Date: Oct 26, 2000

To: T10 Committee (SCSI)

From: George Penokie (Tivoli Systems)

Subject: Defining Targets/Initiators as Ports

Figure 4 - Basic SCSI hierarchy

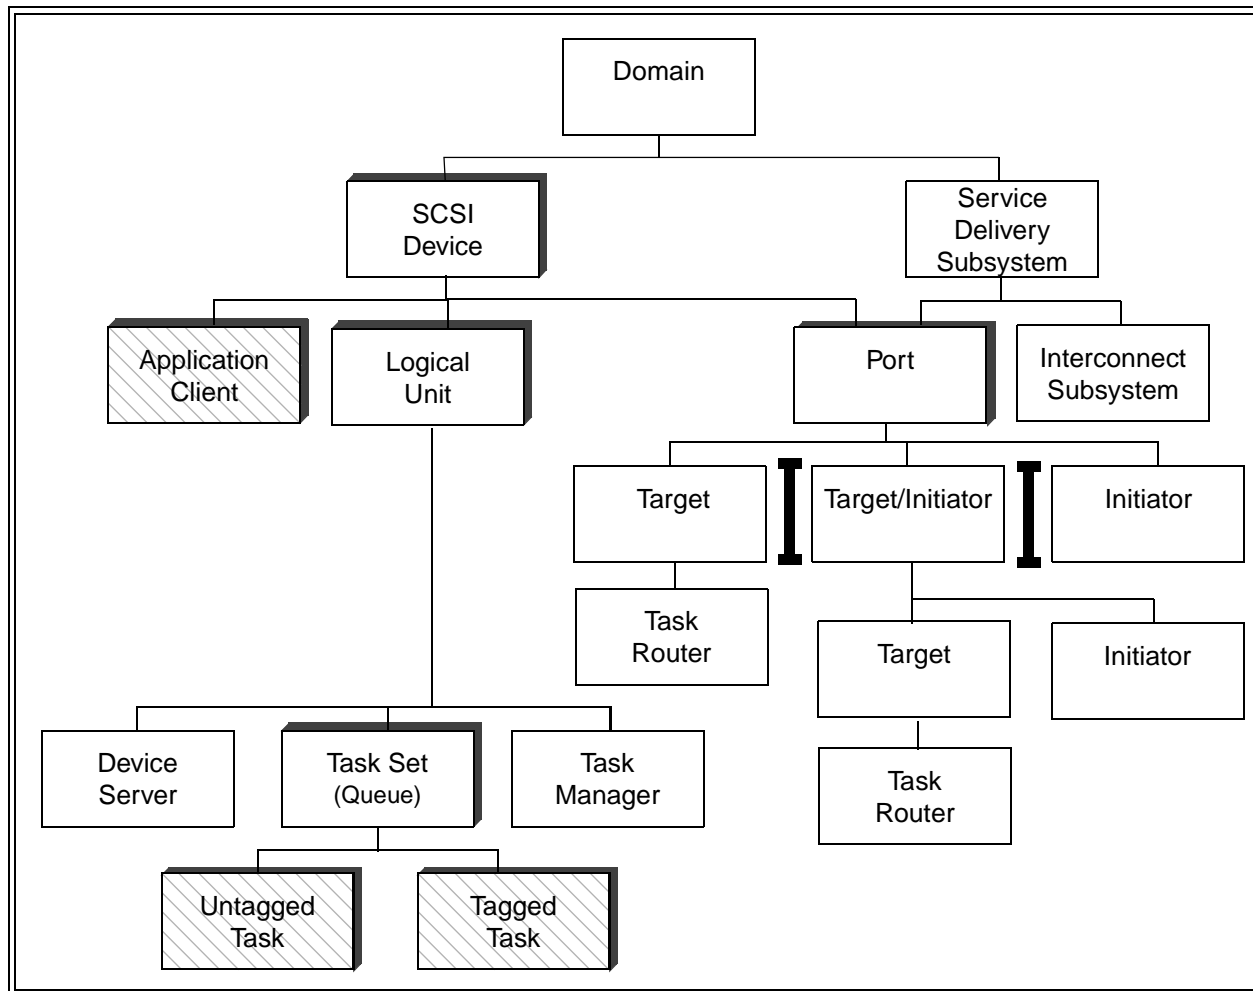
The following show the changes to figures in section 4 of SAM-2 that would be required to change to support a port = target/initiator model.

Figure 4 shows the main functional components of the basic SCSI hierarchy. The following clauses define these components in greater detail.

Figure 5 - SCSI Device hierarchy diagram

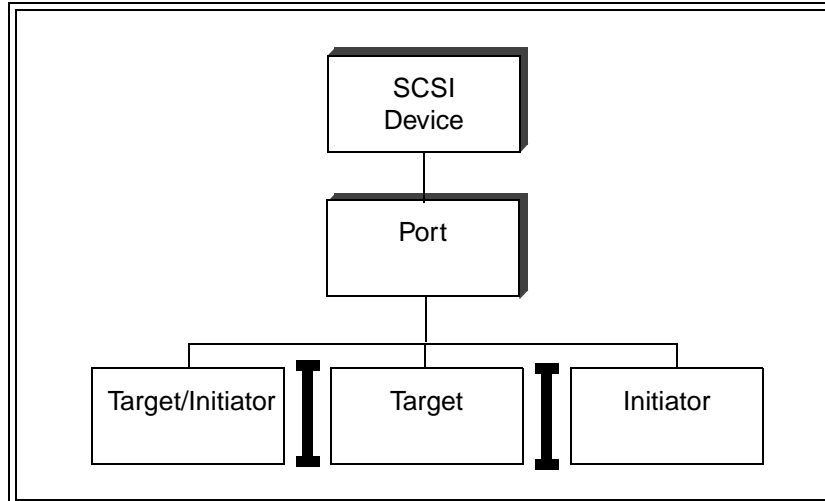
In the basic structural model, a SCSI device (see figure 5) is composed of one or more ports (see 4.6) each of which is a target, initiator, or target/initiator.

Figure 6 - SCSI device functional models

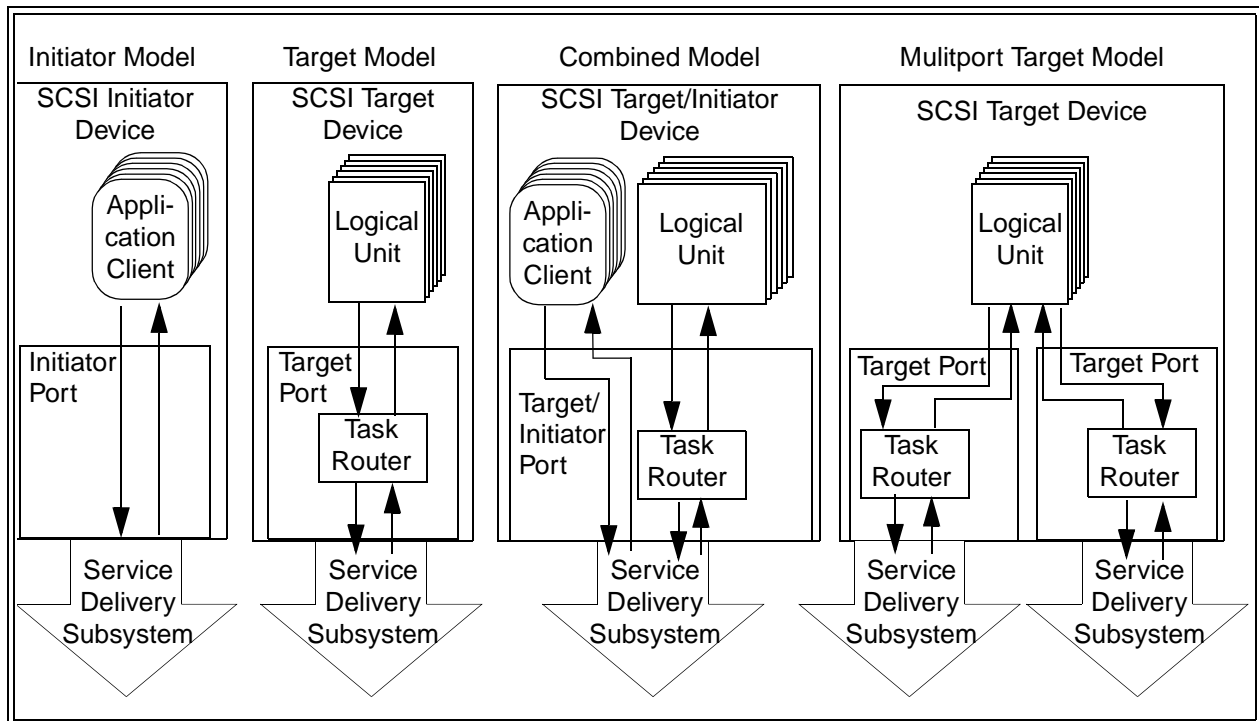
There are several models for implementing ports in an SCSI device, some are shown in figure 6. An SCSI device may contain only target ports, only initiator ports, only target/initiator ports or any combination there of.

Figure 7 - Initiator hierarchy diagram

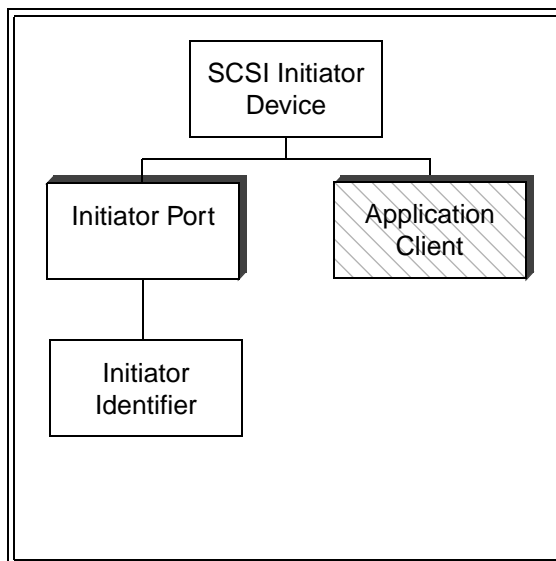
A SCSI initiator device (see figure 7) is composed of a task router and an Initiator Identifier for each initiator port and zero or more application clients.

Figure 8 - Target hierarchy diagram

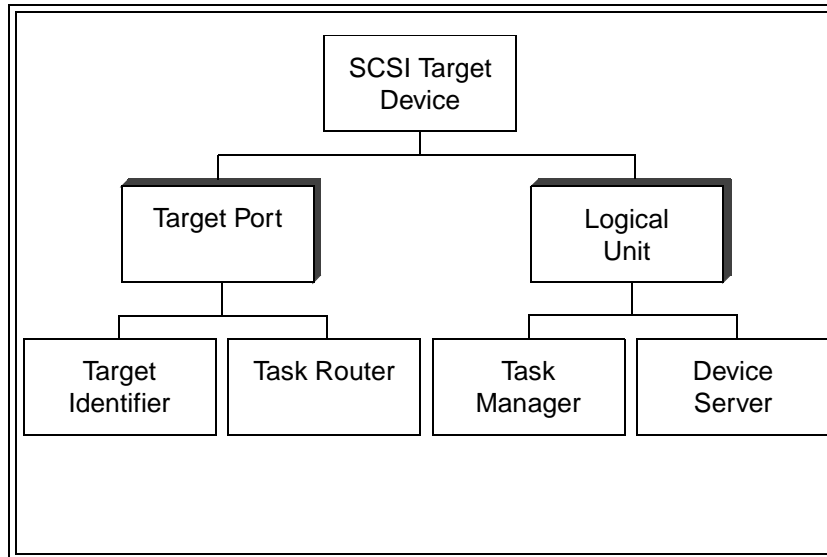
A SCSI target device (see figure 8) is composed of a task router and target identifier for each target port and one or more logical units composed of a task manager and a device server.

Figure 9 - Target hierarchy diagram

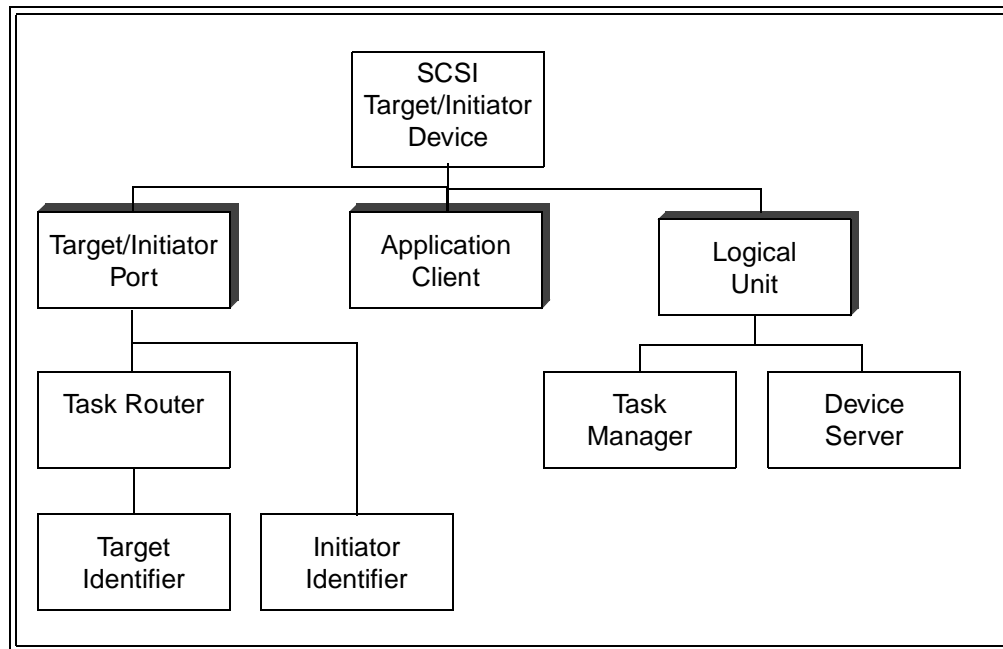
A SCSI target/initiator device (see figure 8) is composed of a task router and target identifier or initiator identifier for each target/initiator port and one or more logical units composed of a task manager, application client, and a device server.

Figure 10 - Multiple port target SCSI device structure model

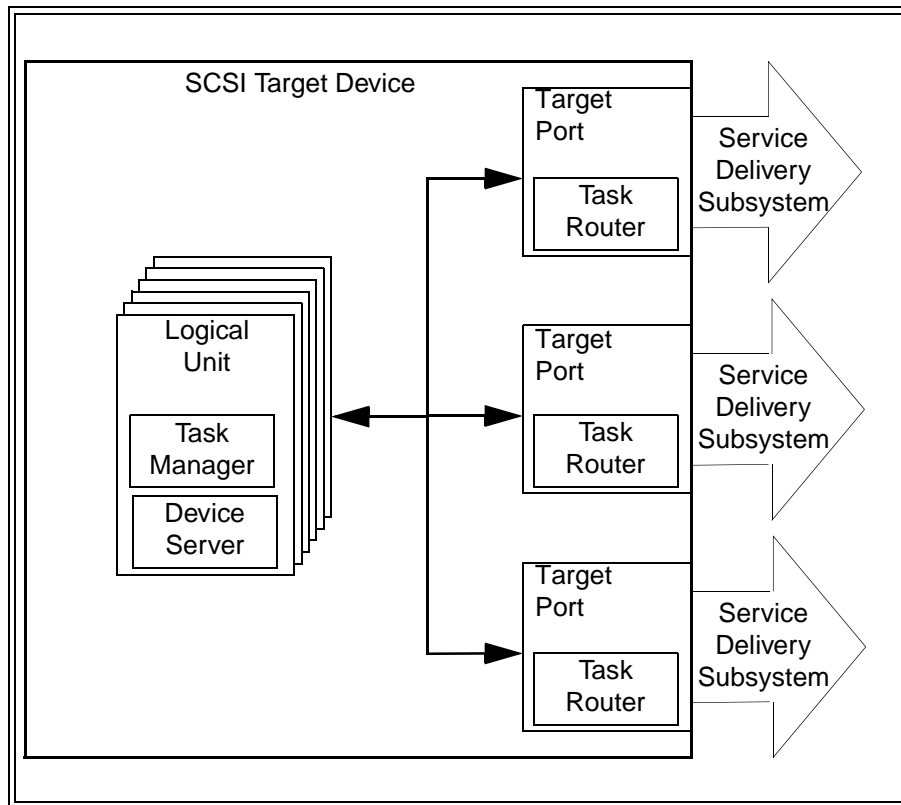
Figure 10 shows the structure of a SCSI target device with multiple target ports. Each target port consists of a task router and is shared by a collection of logical units. Each logical unit contains a single task manager and a device server.

Figure 11 - Multiple port SCSI initiator device structure model

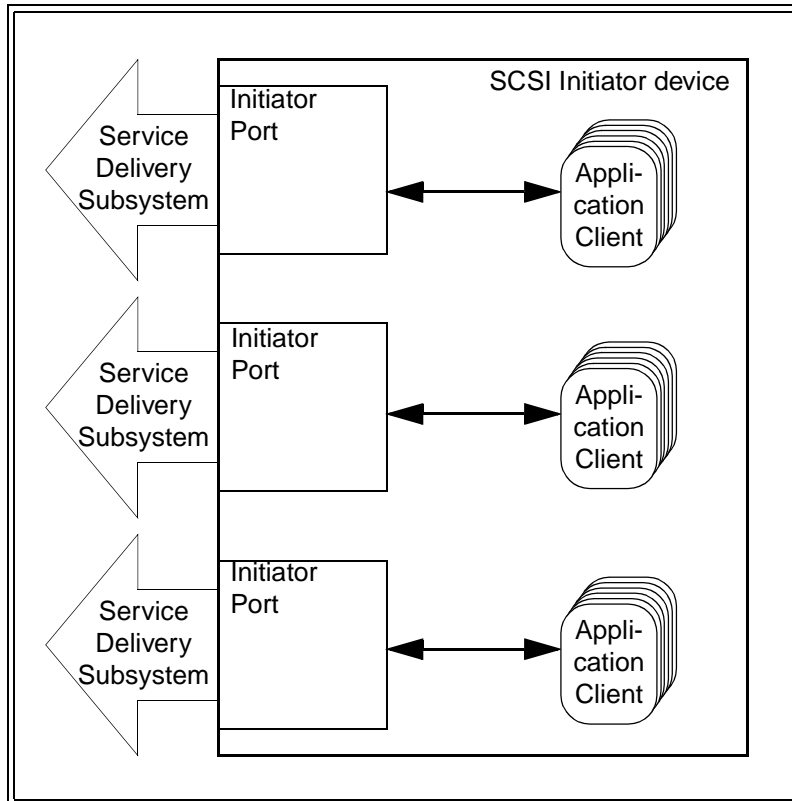
Figure 11 shows the structure of a SCSI initiator device with multiple initiator ports. Each initiator port consists of a task router and is shared by a collection of application clients.

Figure 12 - Multiple port target/initiator SCSI device structure model

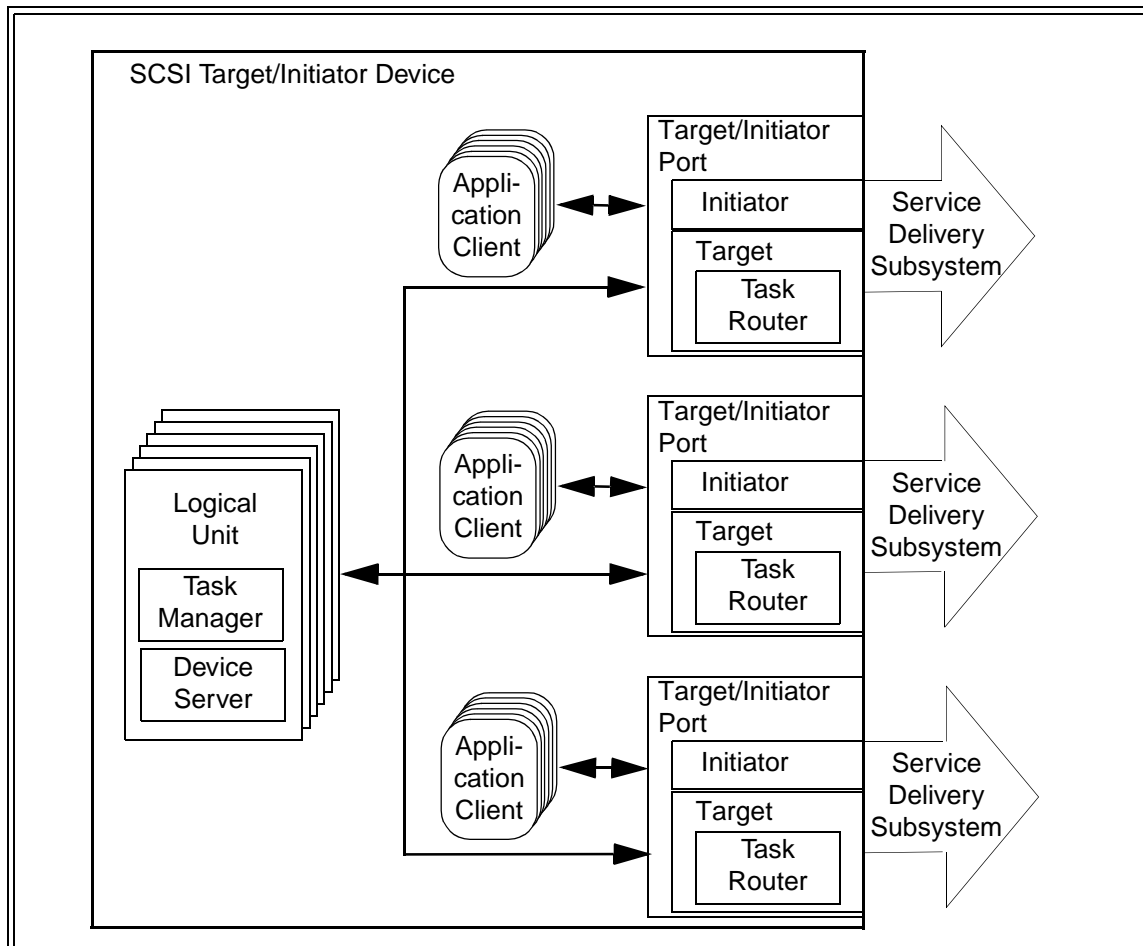
Figure 13 shows the structure of a SCSI target/initiator device with multiple target/initiator ports. Each target/initiator port consists of a task router and is shared by a collection of logical units. Each logical unit contains a single task manager, a device server, and an application client.

Figure 13 - SCSI target device configured in a single SCSI Domain

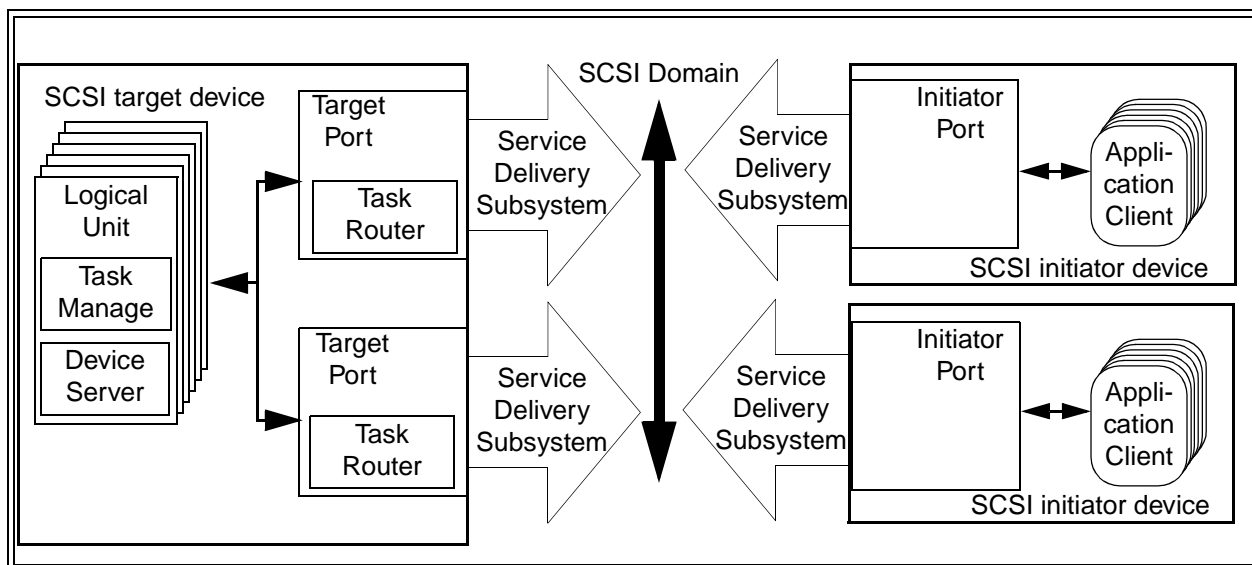
Figure 13 shows a SCSI target device with multiple target ports participating in a single SCSI Domain with two SCSI initiator devices. There are three SCSI devices, one of which has two target ports, one with one initiator port, and one with one initiator port. There are two Target Identifiers and two Initiator Identifiers in this SCSI Domain. Using the INQUIRY command Vital Product Data page as described in xxx, the application clients in each of the SCSI initiator devices that have the ability to discover the logical units in the SCSI target devices are accessible via multiple Target Identifiers (target ports) and map the configuration of the SCSI target devices.

Figure 14 - SCSI target device configured in multiple SCSI Domains

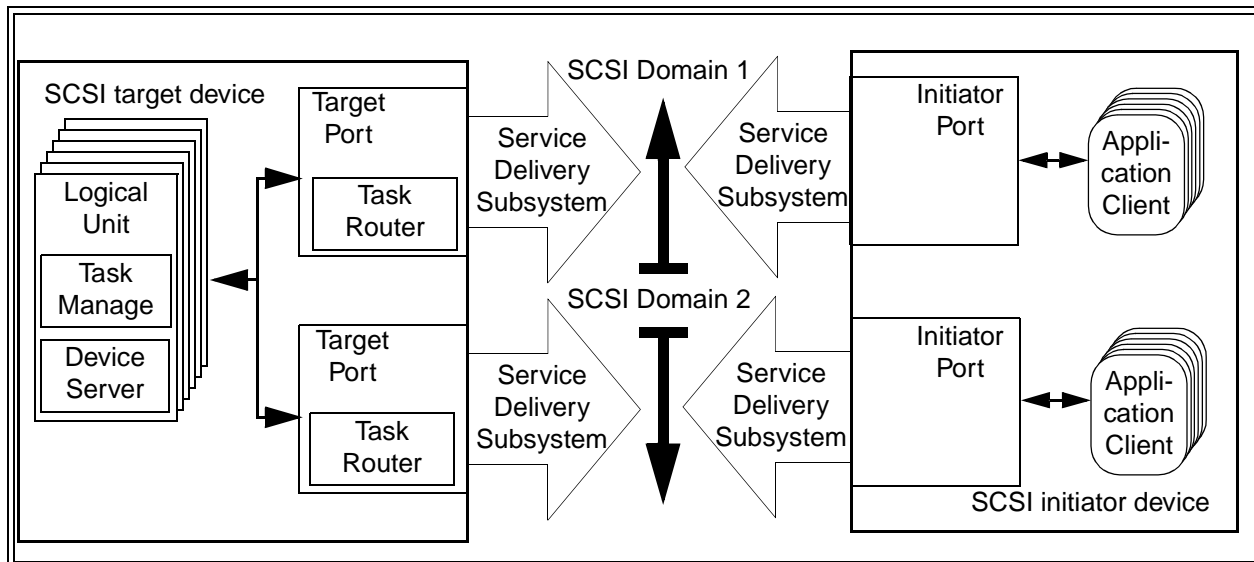
Figure 14 shows a SCSI target device with multiple target ports participating in two SCSI Domains and a SCSI initiator device with multiple initiator ports participating in the same two SCSI Domains. There is one SCSI target device two target ports and the a SCSI initiator device with two initiator ports. There is one Target Identifier and one Initiator Identifier in each of the two SCSI Domains. Using the INQUIRY command Vital Product Data page as described in xxx, the application clients in the SCSI initiator device have the ability to discover that logical units in the SCSI target device are accessible via multiple ports and map the configuration. However, the methods available to application clients to distinguish between the configuration family shown in figure 14 and the configuration shown in figure 22 may be beyond the scope of the SCSI family of standards.

Figure 15 - SCSI target device and SCSI initiator device configured in a single SCSI Domain

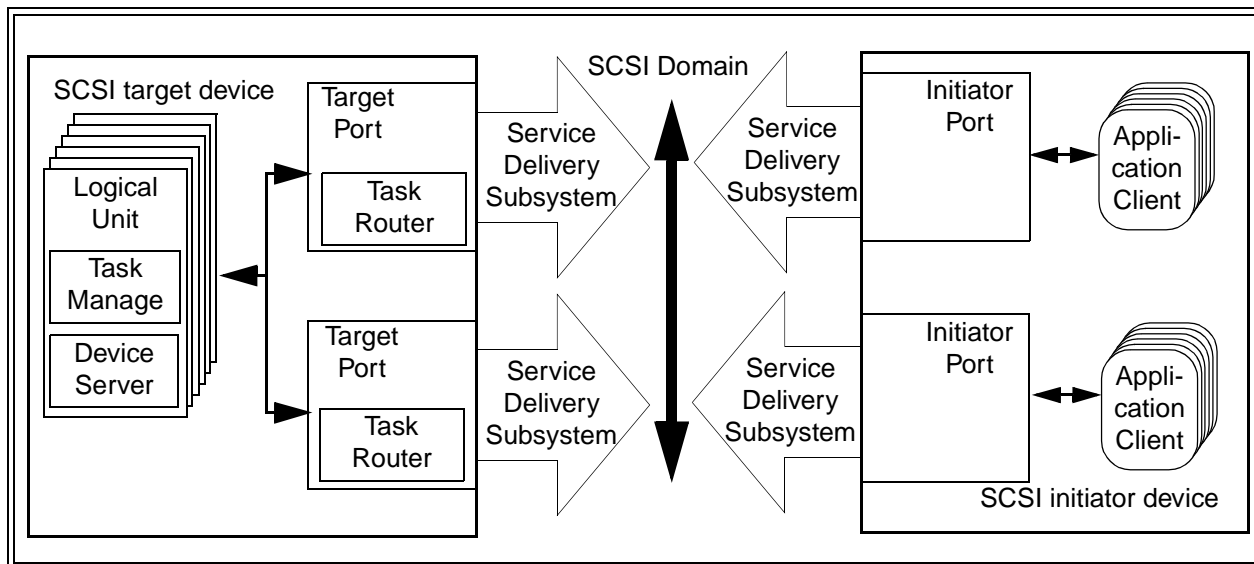
Figure 15 shows the same configuration as figure 14 except that the two SCSI Domains have been replaced by a single SCSI Domain.
